SEPTIC: IMPROVEMENT PERMIT / AUTHORIZATION TO CONSTRUCT / OPERATION PERMIT / EXISTING SYSTEM

PERMIT # OSWP 2024-50318 ✓

SUBDIVISION: Society Manor ✓ SECTION: n/a LOT # 4 ✓ LOT AREA: 1.01 DESIGN FLOW: 360 L.T.A.R.(Initial): 0.3 L.T.A.R (Repair): 0.3

Septic System Design for a 3 Bedroom House
ACCEPTED using PMANIFOLD distribution
Site location: 594 Vaughn Mill Rd, Lot # 4

AS BUILT SKETCH

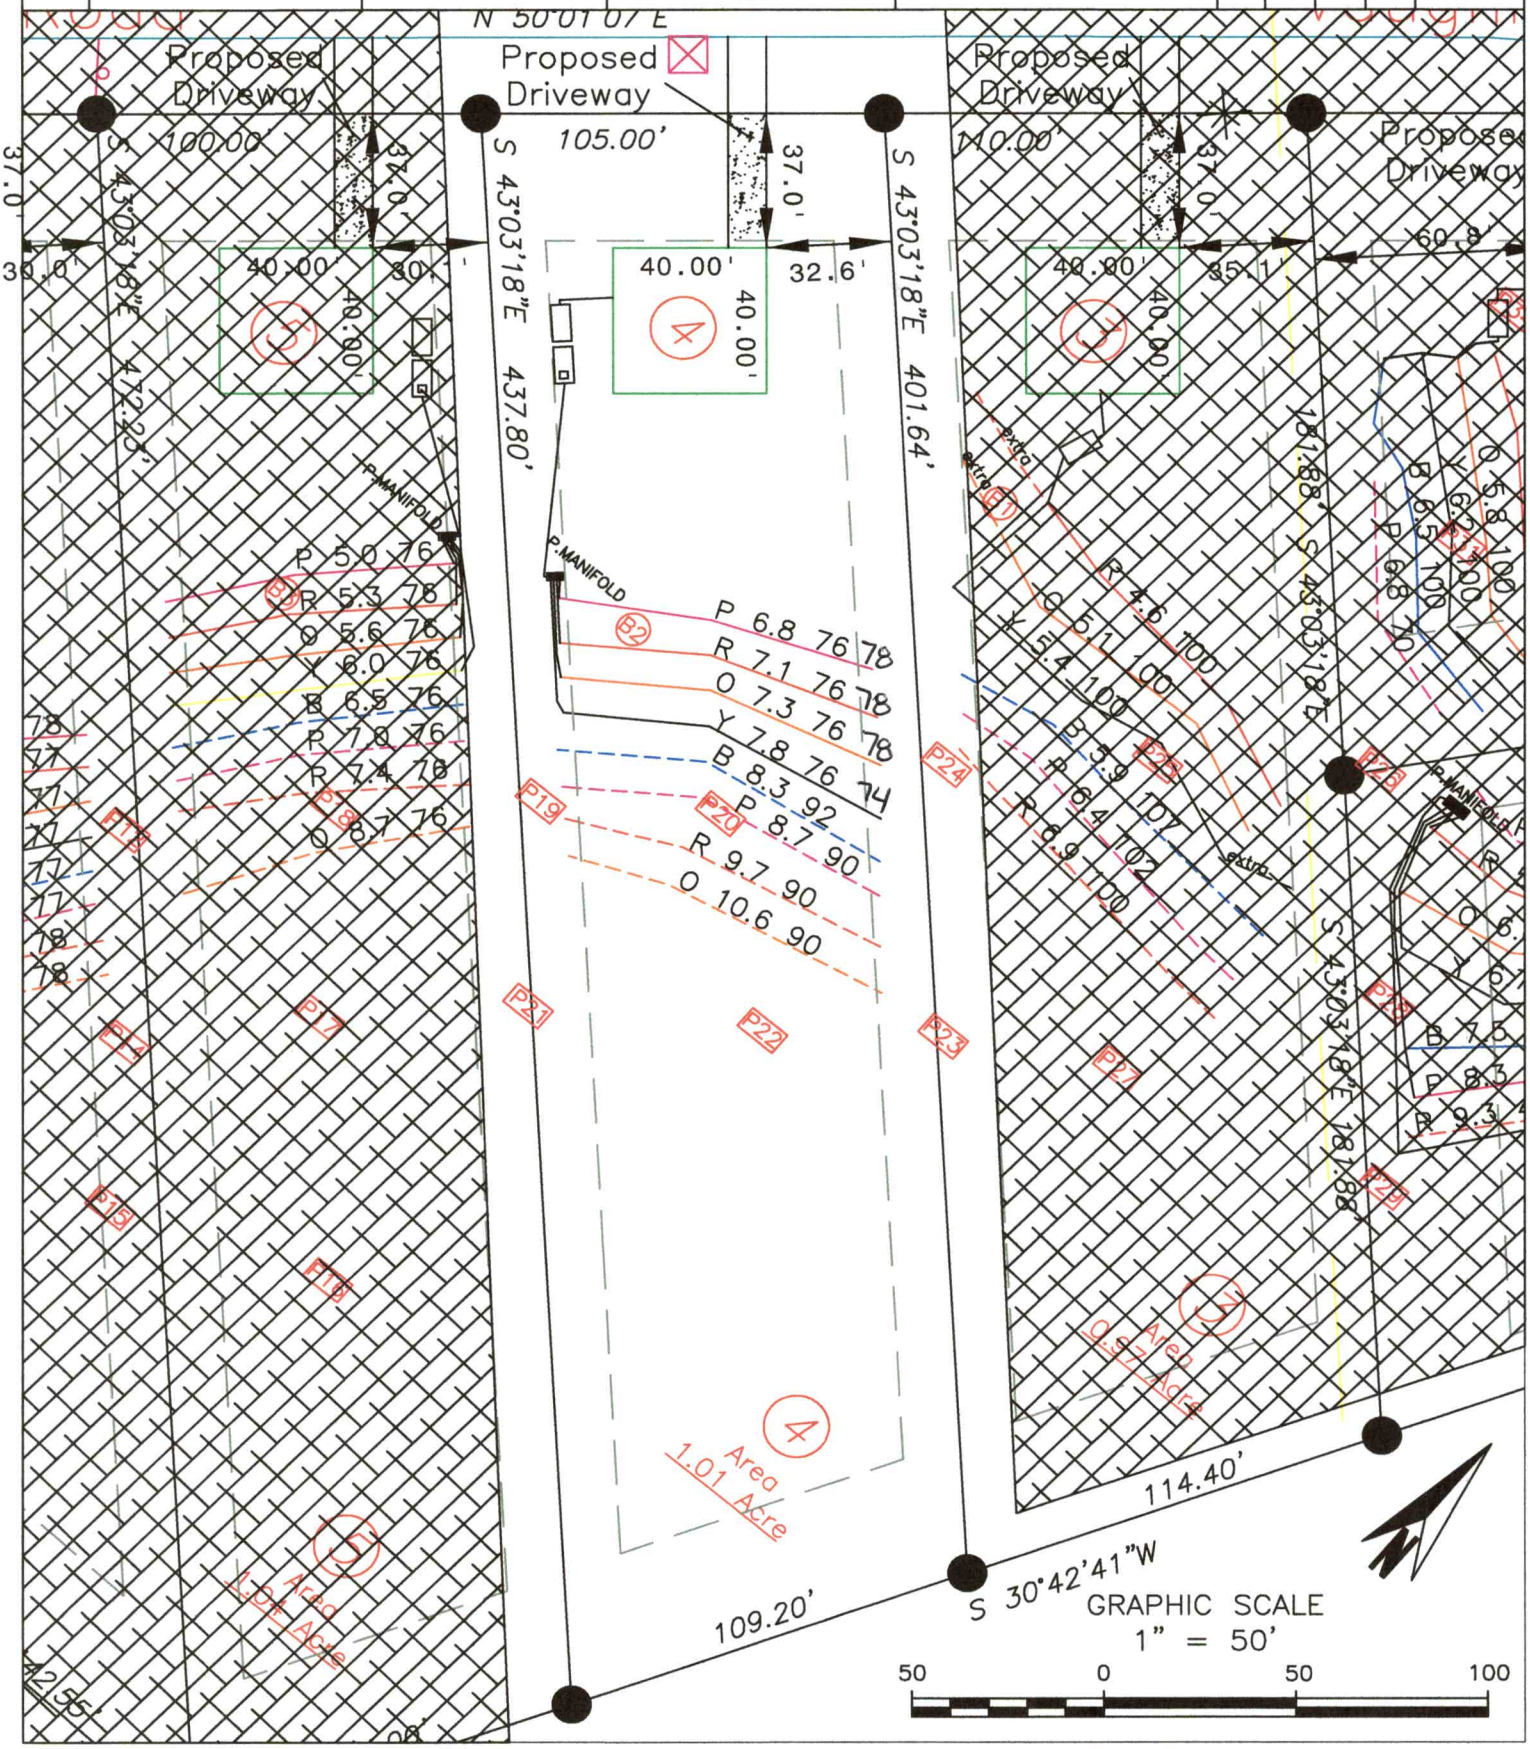
PT to be reset 3" out of level

LINES AS DRAWN
